City Council Agenda Item #14D
Meeting of April 10, 2006

Brief Description: Items concerning grade changes and a pervious patio on the lake access lot at 17024 Gray's Bay Boulevard for Lakewest Landscape.

Recommended Action: Adopt the resolution, which approves the conditional use permit and the floodplain alteration permit, but denies the setback variance.

A13

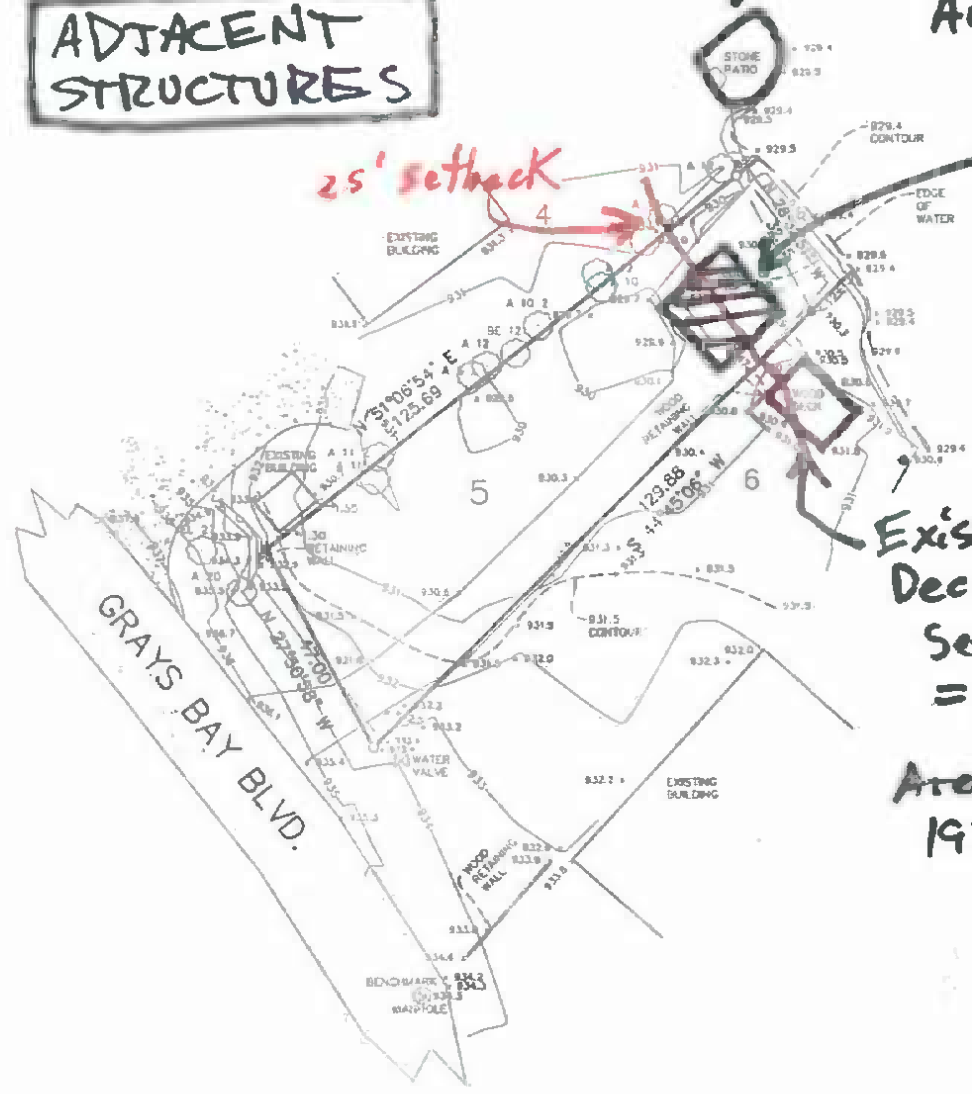
- 1) The proposed patio would be set back farther from the shoreline than the deck and patio on the two adjacent lakeshore lots. (See page A13.)
- 2) A significant portion of the patio (44%) would meet the required 25-foot setback. The portion extending into the setback (180 square feet) would be no larger than the size of the two existing structures located on the neighboring lots. (See page A13.)

No. While staff had previously supported this variance, the council did not think the findings were sufficient to justify the variance. Staff has since reviewed the applicant's latest letter. Staff does not concur with the applicant's engineer. Staff believes that there are other reasonable options. The patio could be moved back to meet the setback requirement. If the applicant is concerned about the additional fill required or drainage issues, the patio could be reduced in size. Staff believes that the patio could be reduced in size and still be a reasonable size. To maintain use of the area in front of the patio, the applicant could use other materials that would not be subject to setbacks, such as reinforced turf or a geo-grid type material with rock infill. Since this material is under the grass and pervious, it would not be subject to setbacks.

Callison was not concerned about the proposed use, but questioned the practical difficulty that would warrant the variance—she did not see a practical difficulty. Olson suggested looking at the adjacent properties for frontyard setbacks as an example of what is reasonable and, therefore, a practical difficulty. The applicant is trying to maximize the recreational use of his parcel. Callison said that we'll never get the uses pushed back if we continue to use them as justification to develop close to the lakeshore.

Schneider noted that the adjacent decks and patios are non-conforming. He could not see a practical difficulty in this case, and thought it was a matter of personal preference. The setback and use may be appropriate. If this is not an unreasonable use, the city should change the ordinance to allow pervious pavers closer to the lake.

- 1) The proposed variance is denied for the following reasons:
 - a. The patio can be reduced to a reasonable size and moved back to meet setbacks.
 - b. There are other options to use the setback area that would not require a setback variance.
 - c. While the adjacent properties have patios closer to lake, those patios are illegal or legal nonconforming uses.
- 2) The proposed conditional use permit and floodplain alteration permit are approved for the following reasons:
 - a. The proposed use would have low damage potential. Flood flows would not be obstructed, no net fill will occur, water storage would be maintained, and there would be no increase in the flood elevation.
 - b. All fill material and exposed soil will be protected by vegetation or stone.
 - c. No impact will occur to significant trees, wetlands, or public easements.

A15

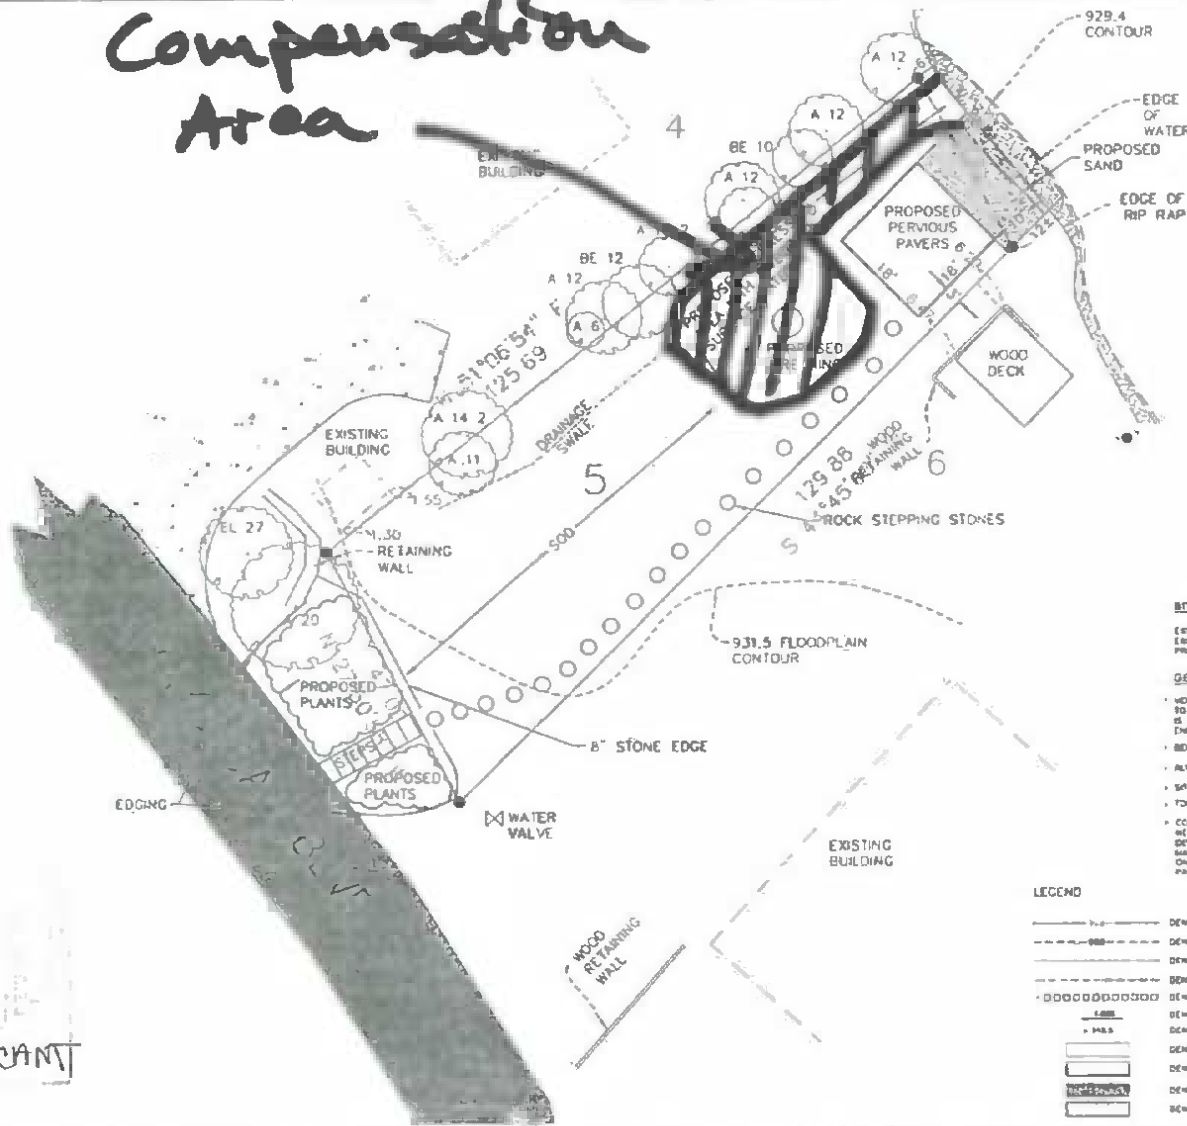
Yes. No net fill would occur within the floodplain. A depression would be excavated to compensate for the amount of fill placed on the lot. (See page A15.) Grading would remain slightly lower than the adjacent property and flow will be unobstructed across the lot. Because most of the lot is within the floodplain, any grading on the site would result in alteration of the existing floodplain. (See page A16.)
